SITE PLAN & ARCHITECTURAL COMMISSION AGENDA JUNE 19, 2015

Starbucks and Office Building
AC-15-013/E-15-060
Revised Conditions of Approval
June 05, 2015

SITE PLAN

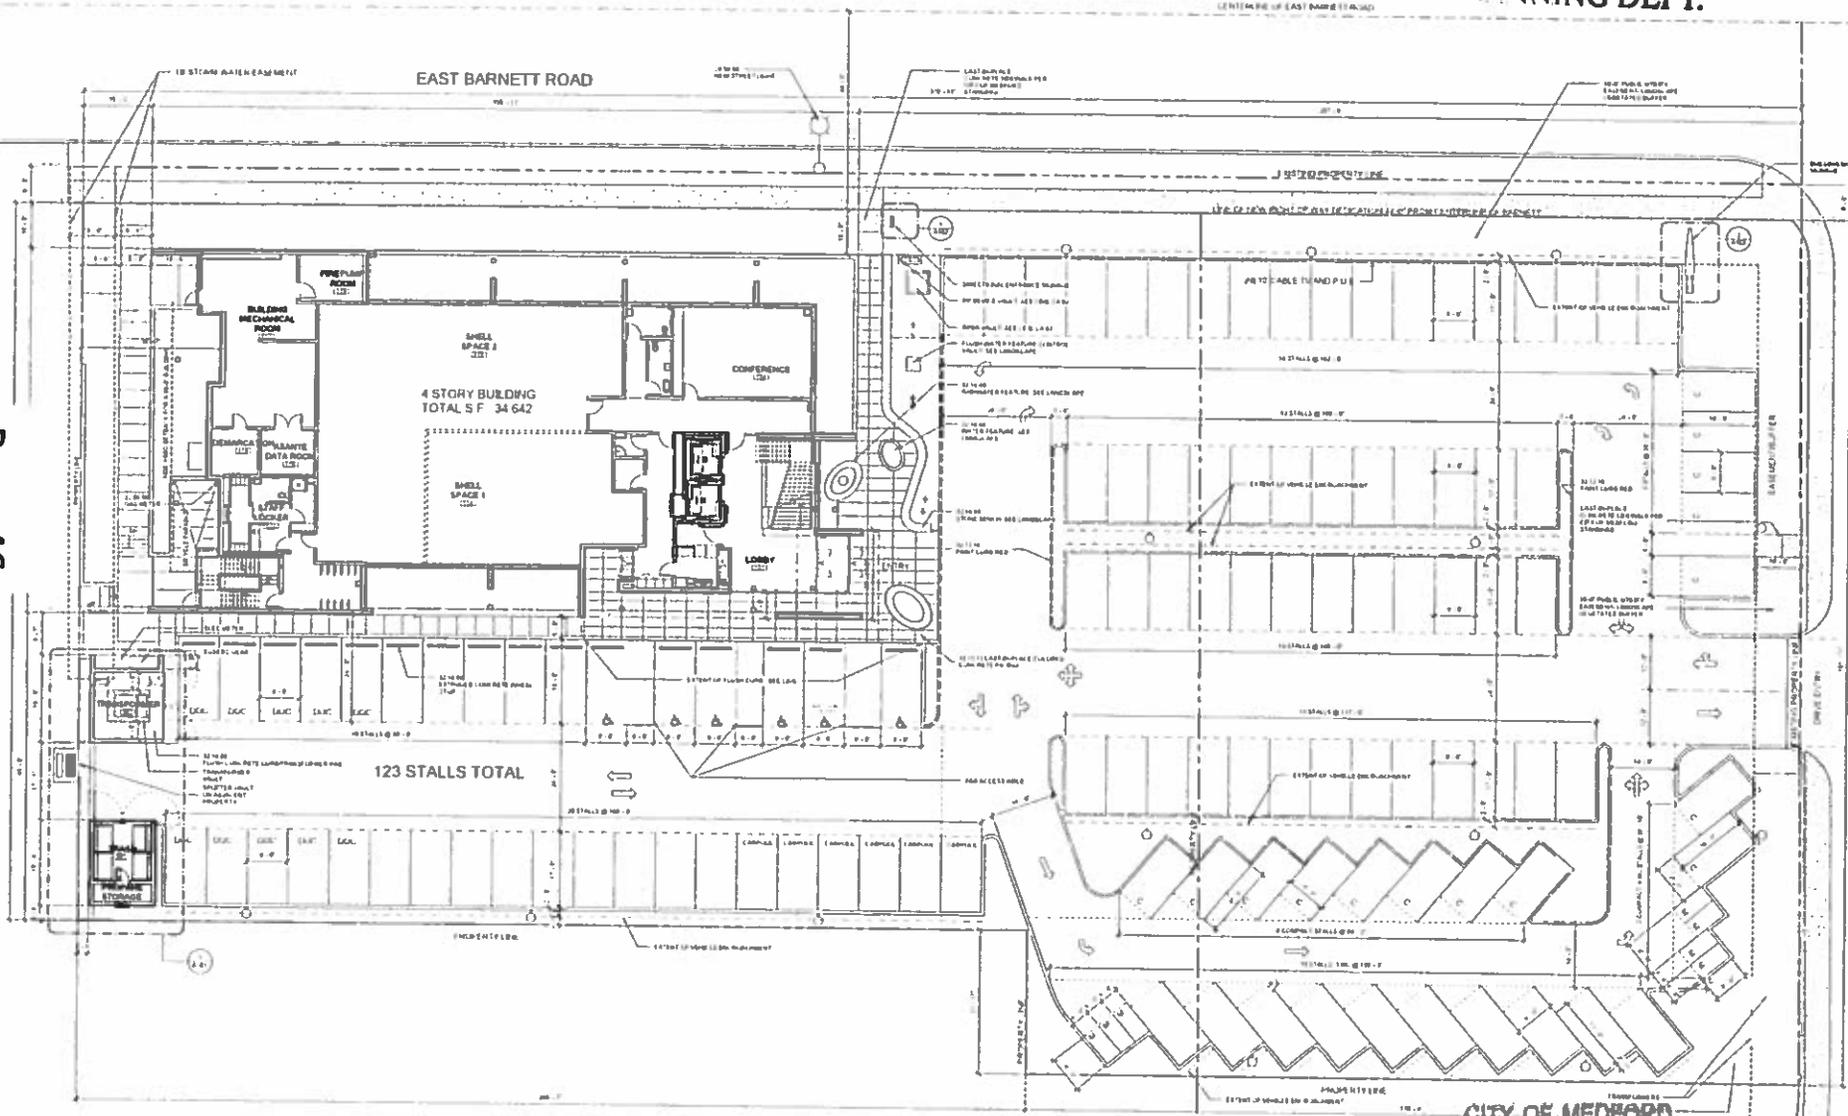
The subject site is bounded by East Barnett Road on the north with 351 linear feet of frontage and State Street on the east with 191 linear feet of frontage. East Barnett Road is identified in the *Transportation System Plan's (TSP) Medford Street Functional Classification Plan* as a Major Arterial Street while State Street is classified as a Commercial Street. Vehicle access to the site will be from State Street via a 24 foot wide driveway. A pedestrian walkway to the site will be provided off of East Barnett Road and connect to a public plaza described below. There is no such walkway provided from the State Street frontage. As a condition of approval, submittal of plans for building permits shall include a pedestrian walkway from State Street to the building entrance per MLDC Sections 10.772–10.776.

This project requires six accessible parking spaces, one of which shall be designated as a "Wheelchair User Only" space, and the revised Site Plan complies with this requirement.

Decision: Applicant provided a revised Site Plan (Exhibit I-1) at the hearing that includes a pedestrian walkway off of State Street onto the subject site, and the Commission approved this revised Site Plan. The condition of approval regarding the pedestrian walkway has been removed.

Decision: At the public hearing, the applicant submitted a revised site plan showing a total of 123 parking spaces. The following section has been revised based on the revised number of spaces.

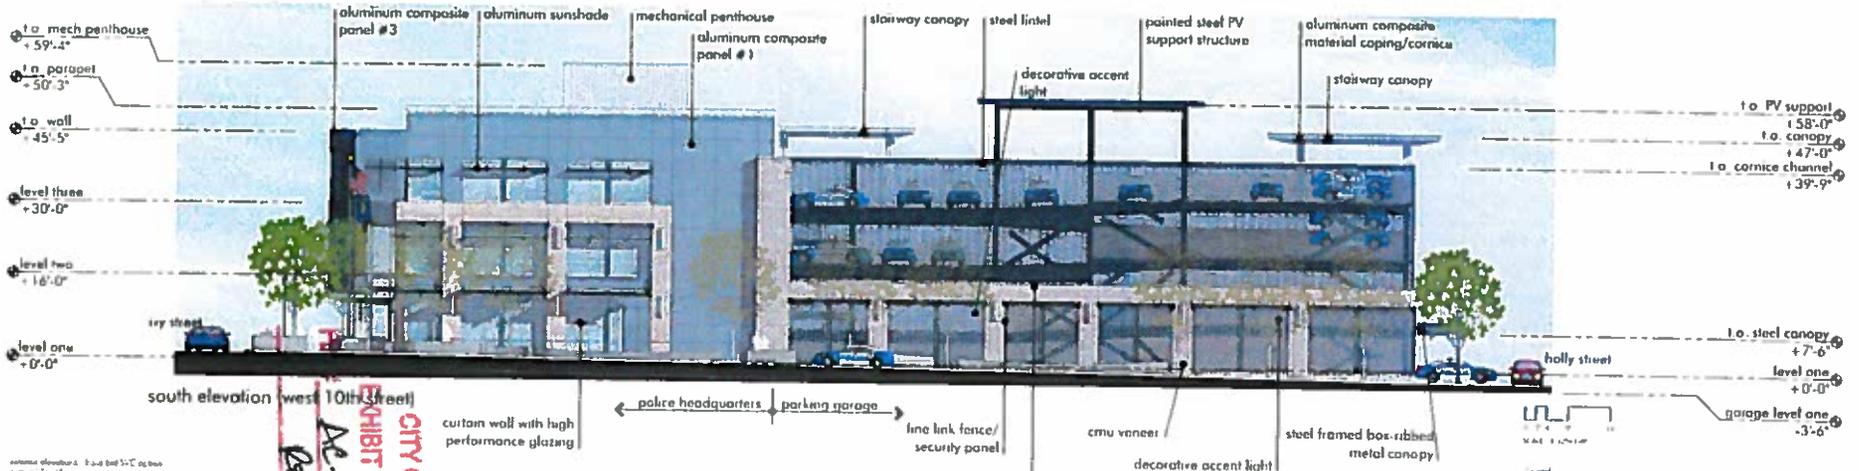
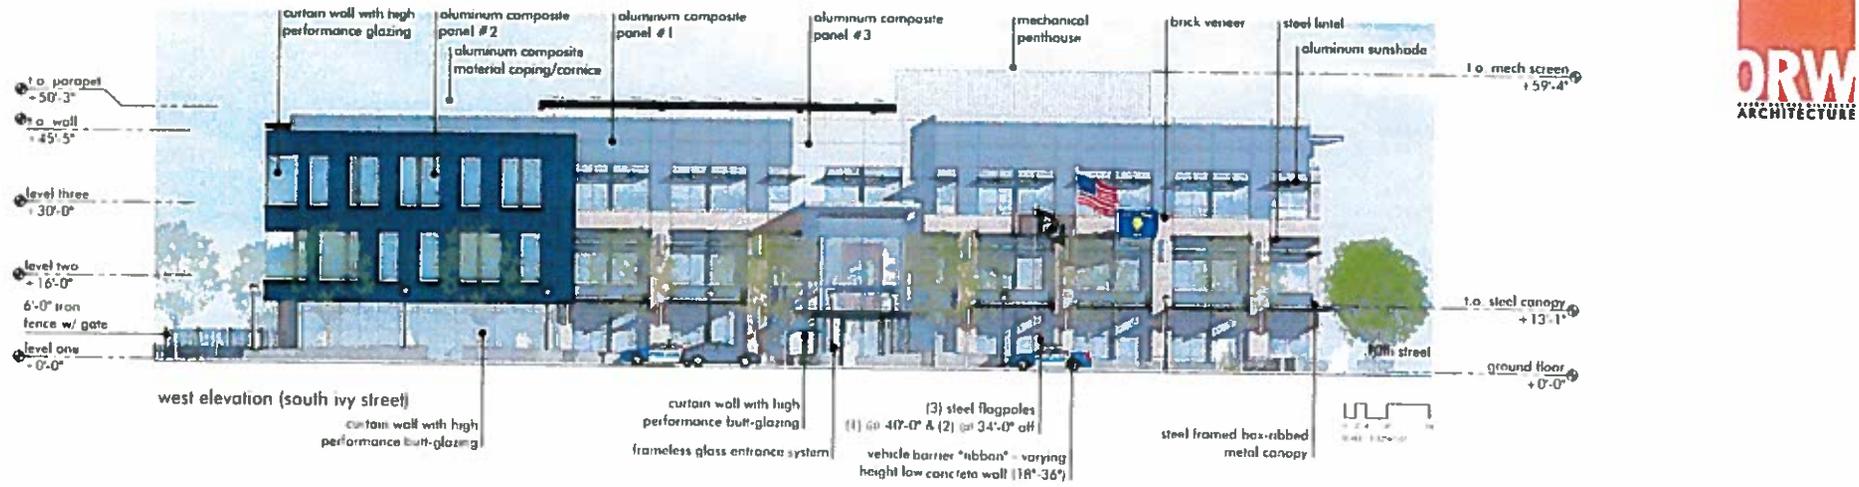
As you know, the design of this project has continued to evolve since we obtained Site Plan approval for this project last year. As part of this process, the city's project team directed us to make several changes to the design, in order to keep the project on budget. One of these changes involves the exterior design of the Secure Vehicle Circulation facility (SVC), the structured parking component of the project. This design is noticeably different than what was submitted for Site Plan approval, as shown on the attached "Base Bid" images. This Base Bid option represents a design that fits within the project budget.

Since this design is not the preferred option of ORW or the project team, we also are preparing an alternate design. If the project cost comes in under budget (or if the budget is increased for some reason), then the city can choose to build this preferred design, as shown in the attached "Add Alternate Bid" images. This Alternate Bid option represents the design that is preferred by both the project team and the city council, and it is very similar to what was submitted last year for Site Plan approval.

Via this letter, we are submitting both alternate designs for SPAC approval. At this time, we do not know which option the city can afford, so we would like approval of both. Due to the project schedule, we cannot delay this decision until the final bids are received. Instead, we would like to get SPAC's approval of both options. We will notify you of the option that is selected, for your records.
